TECHNICAL MEMORANDUM

West Harlem Rezoning FEIS

CEQR No. 12DCP070M

Comparison of Zoning Lot Boundary to be Modified – FEIS vs. Technical Memorandum for Potential CPC Modifications

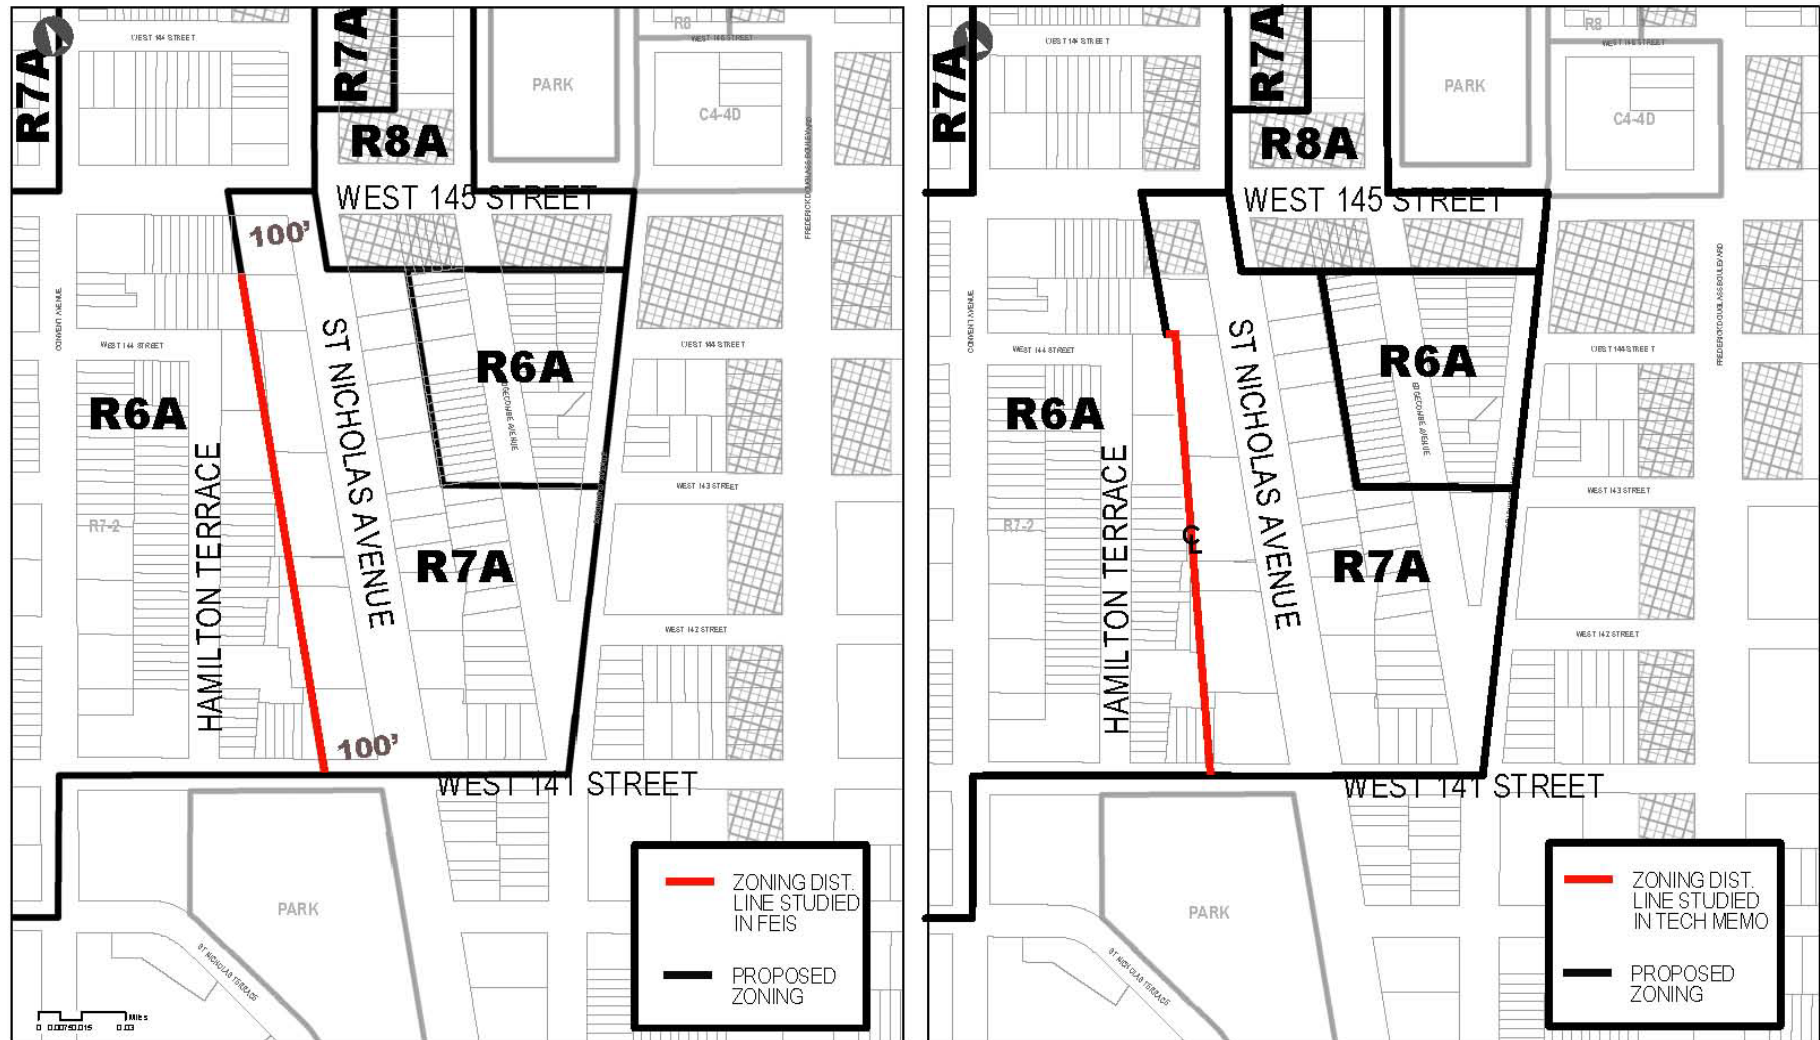
Properties fronting on St. Nicholas Avenue between West 141st and West 145th streets contain rear lot lines that vary beyond 100 feet west of St. Nicholas Avenue (due to the block’s geometry) and that the proposed zoning district boundary location has resulted in an inadvertent split lot condition (R7A and R6A). Therefore, the Potential CPC Modifications include the modification of the zoning map amendment in order to relocate the zoning district boundary to the centerline of the block, which is an adjustment ranging from 0 to approximately 40 feet, as illustrated in Figure 1. This technical correction to the proposed zoning map would not affect any of the analyses of the FEIS or alter any of its conclusions. Therefore, no further analysis of this modification is warranted.

As noted above, the Potential CPC Modifications include modification of the proposed zoning map amendment in order to relocate the zoning district boundary west of St. Nicholas Avenue between West 141st and West 145th to the centerline of the block. This boundary modification would not affect the overall land use patterns assessed in the FEIS and established in the future with the Proposed Action, nor would it change the anticipated RWCDs analyzed in the FEIS. Similarly, the proposed modification of the development program analyzed for Projected Development Site 40 would not introduce any new land uses that were not previously included, nor would it affect the overall land use patterns assessed in the FEIS and established in the future with the Proposed Action. The Potential CPC Modifications would, therefore, not result in any significant adverse impact to land use, zoning, or public policy not already identified in the FEIS for the Proposed Action.

FIGURE 2b
Comparison of Site 40 Massing – FEIS vs. Technical Memorandum
New Development Scenario

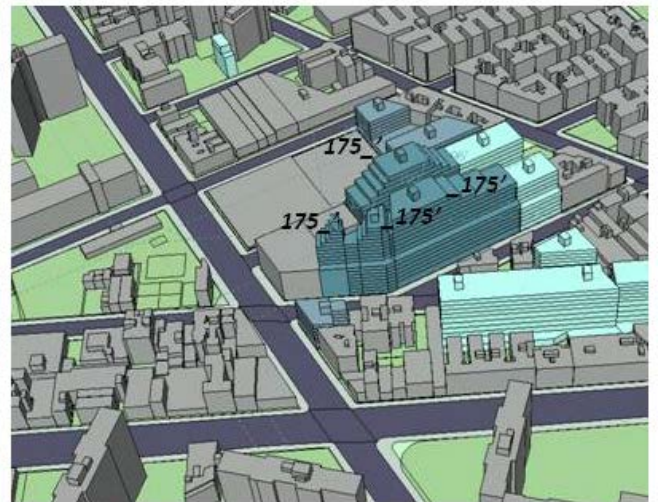
The two existing buildings on tax lot 40 would remain, and the tax lot would transfer 18,526 gsf of development rights to lot 45. Lot 45 would be redeveloped with a 17-story building (height of 175 feet) along West 126th Street, with residential and ground floor retail uses, as well as 52 accessory spaces in a below grade garage along West 128th Street.

Lots 50 and 60 would be combined and redeveloped with a 14-story building (height of 175 feet) along West 127th Street, comprised of a mix of residential, retail, and office uses, as well as 62 accessory parking spaces in a below grade garage along West 128th Street.

Lot 89 would be redeveloped to contain a 15-story building (height of 175 feet) comprised of office and community facility space.

Figure 2 provides a comparison of the two massing diagrams analyzed for Projected Development Site 40 as part of the Proposed Action analyzed in the FEIS, and the massing diagrams associated with the Potential CPC Modifications and analyzed in this Technical Memorandum.

Modified Massing for Technical Memorandum
(floor area from lot 40 transferred to lot 45)

Although the massing of Site 40 under the New Development Scenario would be different compared to what was analyzed in the FEIS (as illustrated in Figure 2), these differences would not be noticeable from street level, and would not be expected to alter the pedestrian experience in the vicinity of Projected Development Site 40. While the differences in massing may be noticeable from farther away there would be little difference in appearance to the pedestrian between the modified Site 40 buildings and those analyzed in the FEIS.
